Land at Downlands Farm, Uckfield

Highways and Transport Evidence on behalf of Gleeson Land and John Alison Land and Research Ltd

PINS Reference: APP/C1435/W/23/3321978
LPA Reference: WD/2022/1637/MEA

Response to ESCC Highway Comments

Drawing: 2001061-118

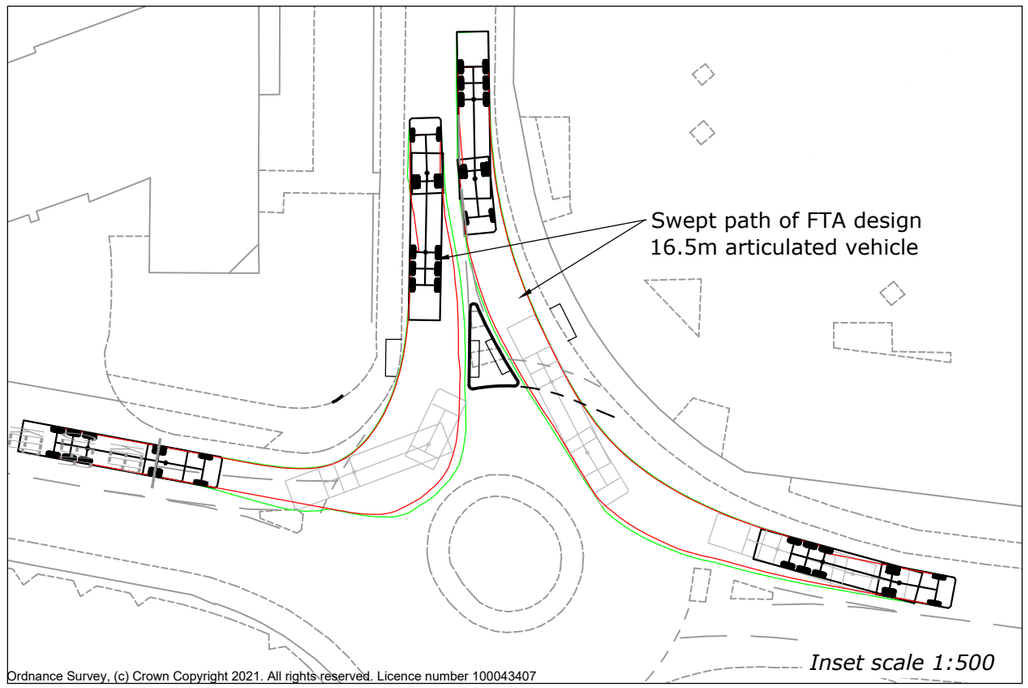
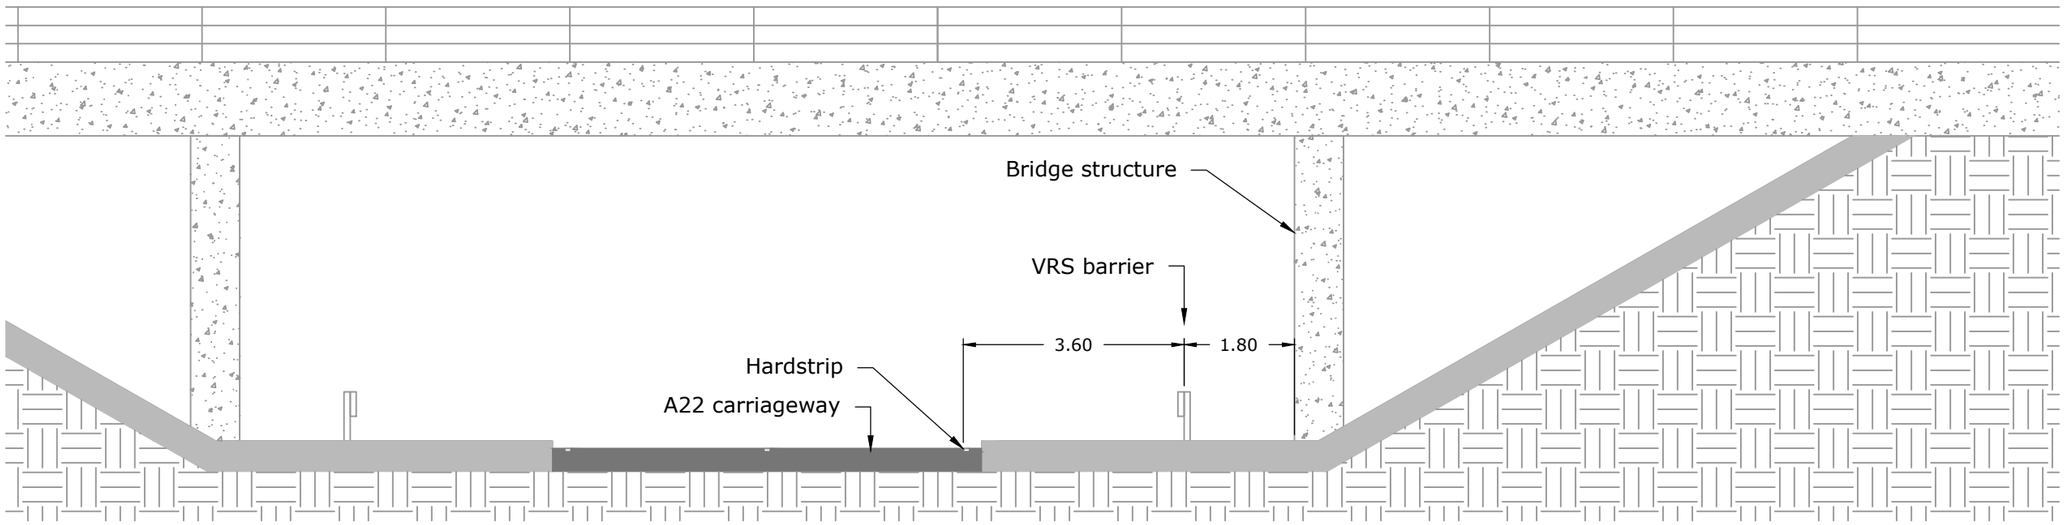
2022 Oct	Bellfarm Road shared route proposals - how do they tie in with the proposals for Gridserve electric charging facility at Copwood Roundabout (see WD/20/1244).	2022 Dec *Relates to Motion drawing 2001061-115* The Gridserve proposals have been added drawing 2001061-115, to ensure that there are no conflicts with the two designs. *Drawing 2001061-115 has been amended to revision B*
2022 Oct	The highway works on Bellfarm Road have not been taken into account the accessibility improvements secured as part of Gridserve development on the west side of the Copwood Roundabout.	2022 Dec *Relates to Motion drawing 2001061-115* The proposed highway alterations associated with the Gridserve development have now been added to drawing 2001061-115, shown in blue linetype.
2022 Oct	No provision for westbound cyclists (coming from the High Street) to join the shared route	2022 Dec *Relates to Motion drawing 2001061-118* The provision for westbound cyclists has been reviewed and drawing 2001061-118 has been revised to include upgrading the existing pelican crossing to a toucan crossing, enabling westbound cyclists to access the shared facility on the northern side of the road. To facilitate this, the proposals now include a short section of footway on the southern side of the crossing to be designated as shared footway / cycleway, with a new dropped kerb so westbound cyclists to access it. In addition to the above, cyclists have the option of choosing an alternative route through Bellfarm Lane (industrial estate), as suggested in the LCWIP. Should there be a preference for this option to be developed, consideration could be given to the suitability of providing a new section of shared footway on Bell Lane (west of Brookside) to provide a link with the new uncontrolled pedestrian / cycle refuge being installed as part of the Gridserve scheme. *Drawing 2001061-118 has been amended to revision A*

2022 Oct	Splitter island north of roundabout will need to be wide enough to accommodate waiting cycles (2m)	2022 Dec *Relates to Motion drawing 2001061-118* The section of the island that will be used by pedestrians and cyclists is 1.9 metres wide at the narrower end and 3.5 metres wide at the wider end (note, the island width is determined by adjacent land constraints).
2022 Oct	Look at appropriate treatment on all arms of the roundabout (2 arms facilitate pedestrian crossing movements/ 2 do not).	2022 Dec *Relates to Motion drawing 2001061-118* It is acknowledged that the scheme needs to cater for east and west bound movements; this has been addressed in the comments above with the upgrading of the pelican crossing to a toucan crossing. *Drawing 2001061-118 has been amended to revision A*
2022 Oct	Footway widening on north-eastern corner of roundabout- ensure that larger vehicles turning north to east can make the turn without encroaching on the widened footway	2022 Dec *Relates to Motion drawing 2001061-118* Vehicle tracking for a 16.5 metre long articulated vehicle has been carried out. Swept path plots have been added to drawing 2001061-118. *Drawing 2001061-118 has been amended to revision A*

2022 Oct	Cyclists guided to re-join the carriageway just prior to Bellfarm Lane- issues with conflict in markings (controlled area). Re-joining at conflict point. Look to extend facility east.	2022 Dec *Relates to Motion drawing 2001061-118* The shared facility on the northern side of the road has been extended eastwards as suggested. Drawing 2001061-118 has been amended accordingly. *Drawing 2001061-118 has been amended to revision A*
2022 Oct	At the entrance to Uckfield bus station, off Bell Lane, the developer proposes a block raised pedestrian crossing. The bus station is subject to a programme of improvements in 2022, led by East Sussex Highways. The suitability of the developer's proposal, including its suitability in terms of height, will need to be confirmed by the scheme designer at East Sussex Highways, when this is finalised	2022 Dec *Relates to Motion drawing 2001061-118* The block paved pedestrian crossings are recommendations provided in the LCWIP. It is anticipated that at the detailed design stage, the details will be submitted to ESCC for approval as part of a S278 package, at which stage any conflicts with the bus depot alterations can be discussed in detail. A note has been added to drawing 2001061-118 referencing potential bus depot alterations. *Drawing 2001061-118 has been amended to revision A*

Drawing: 2001061-132

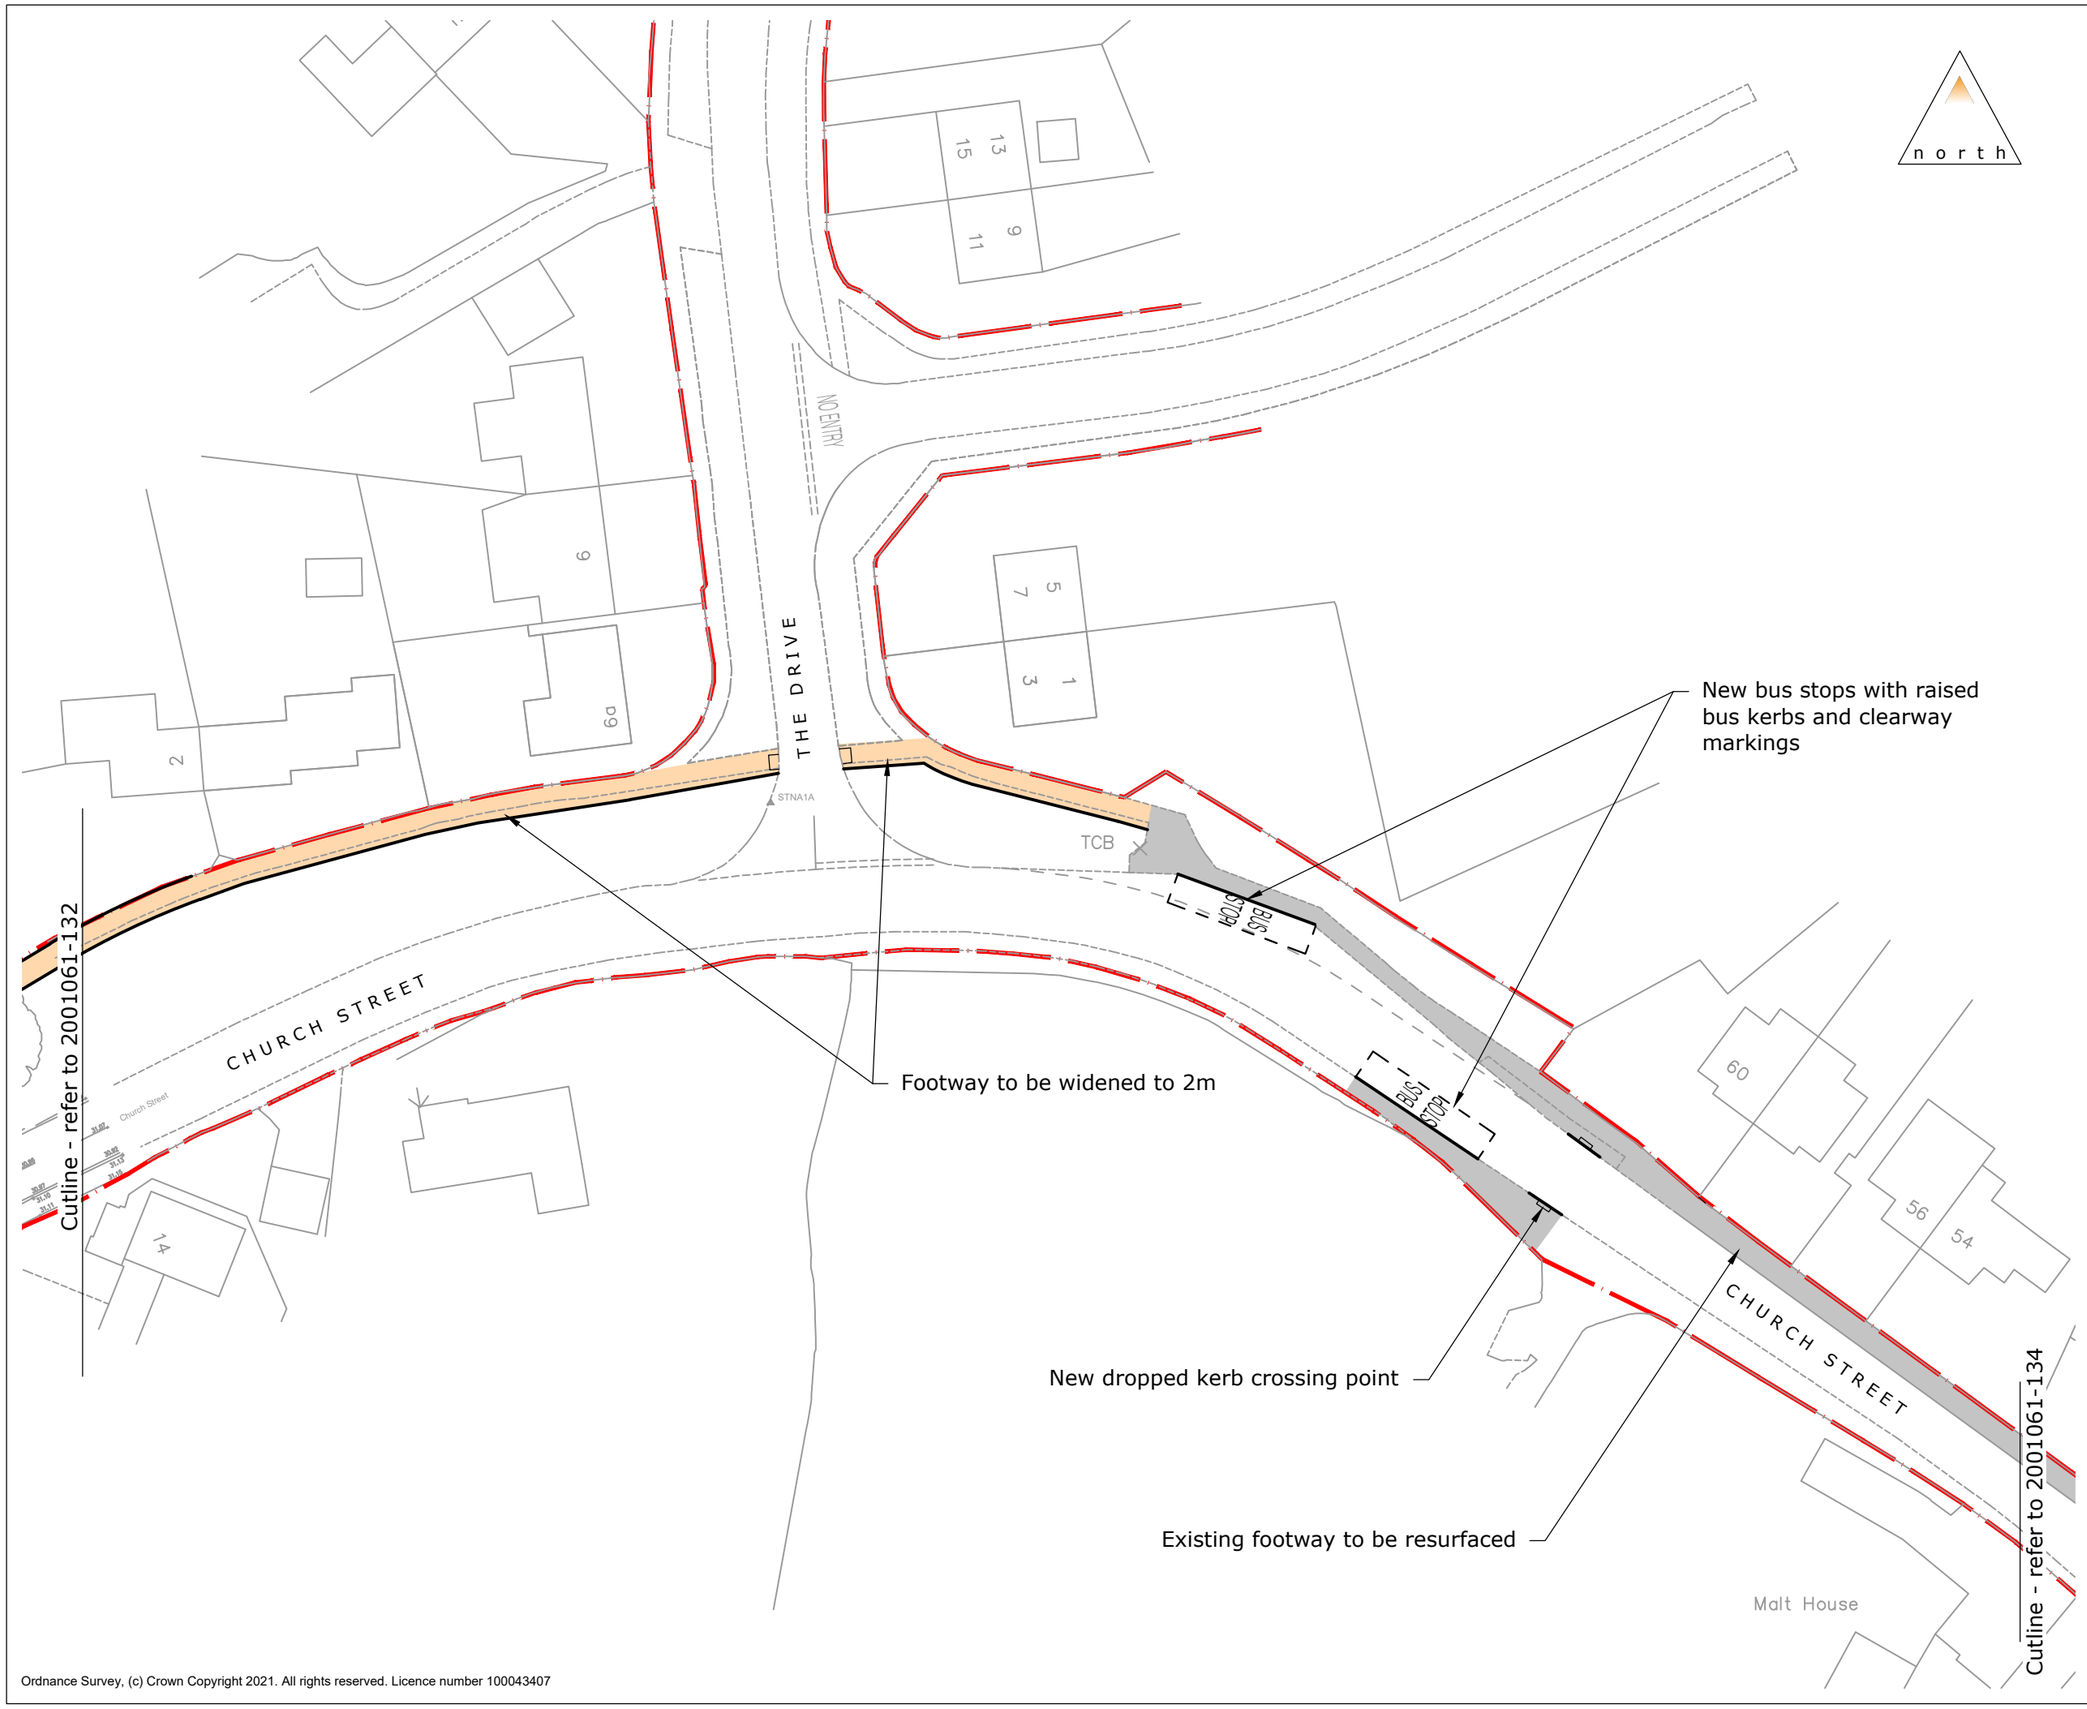
ESCC Comments relating to: Drawing 2001061-131 and 2001061-132 - Rocks Road		
Date	ESCC Comments	*Motion Response*
2022 Oct	The proposed pedestrian/cycle access at the corner of the junction Snatts Road/Rocks Road requires a prominent appearance so that drivers are aware from all approaches of its presence. It is largely wooded and may not be obvious to drivers to expect non-motorised activity given its current rural surroundings. The approach from Rocks Road is likely to require traffic calming to ensure that drivers are travelling at appropriate speeds and awareness of approaching built form. It is likely that a more urban appearance would require continuity from a point west of the active access point, to highlight the environment change to the current defined built up area. The distance over where the 30mph is proposed is largely rural with vegetation dominating the route up to the junction with Hunters Way. It is likely that an engineered solution will be required, given that there is little in the way of frontage development over the ~200m distance.	2022 Dec *Relates to Motion drawing 2001061-131* The proposals include moving the 60mph / 30mph speed limit change from its current location to a point approximately 140 metres to the northwest; this proposal is supported by ATC speed data (as set out in section 2 of Motion's report R03 'Response to ESCC Highway Comments'), the data shows that the 85th percentile traffic speeds on Rocks Road are: SE bound (towards Snatts Rd jct) = 31.4mph NW bound (towards Snatts Rd jct) = 30.3mph This demonstrates that traffic speeds are already well below the signed national speed limit. The proposal to relocate the 30mph speed limit terminal signs will reinforce this by forming a conspicuous transition from wooded rural road to the more urban road environment which has a 2 metre wide footway, street lighting and school entrance. Suitable visibility splays can be achieved at the crossing point which correspond to the 85th percentile speeds. Vegetation clearance and signage details will be specified at the detailed design stage.

2022 Oct	Widened footway on south side of Rocks Road (northwest of Rocks Park Road) appears to be into the carriageway reducing the effective width of the carriageway. Presently the width (roughly just over 6 metres) allows for centre lines and edge of carriageway markings through this tree covered winding road. If the width is reduced the current road marking arrangement will not be possible.	2022 Dec *Relates to Motion drawing 2001061-132* The footway widening proposals include the re-aligning of the Rocks Road carriageway (between the Rocks Park Road and Snatts Road junctions). The existing width of the Rocks Road carriageway along this section varies from 4.8 to 5.8 metres between hard strips; the proposal is to regulate the carriageway width to a consistent width of 5.5 metres.
2022 Oct	There does not appear to be drainage provision upstream of the crossing point northwest of Hunters Way. There does appear to be evidence of ponding (on account of the detritus/ mud collected at the crossing point)- possibility of slips/ falls in wet or icy conditions. Review provision.	2022 Dec *Relates to Motion drawing 2001061-132* Noted, the drainage provision will be reviewed at the detailed design stage and additional gullies will be provided as required.

2022 Oct	The waiting area on the northeast side of Rocks Road (northwest of Hunters Lane) is not accessible for pedestrians, due to lack of maintenance (see photo). Also, a defect in the road in the pedestrian line, which may lead to a fall.	2022 Dec *Relates to Motion drawing 2001061-132* Noted, vegetation clearance and surface repairs will be specified at the detailed design stage.
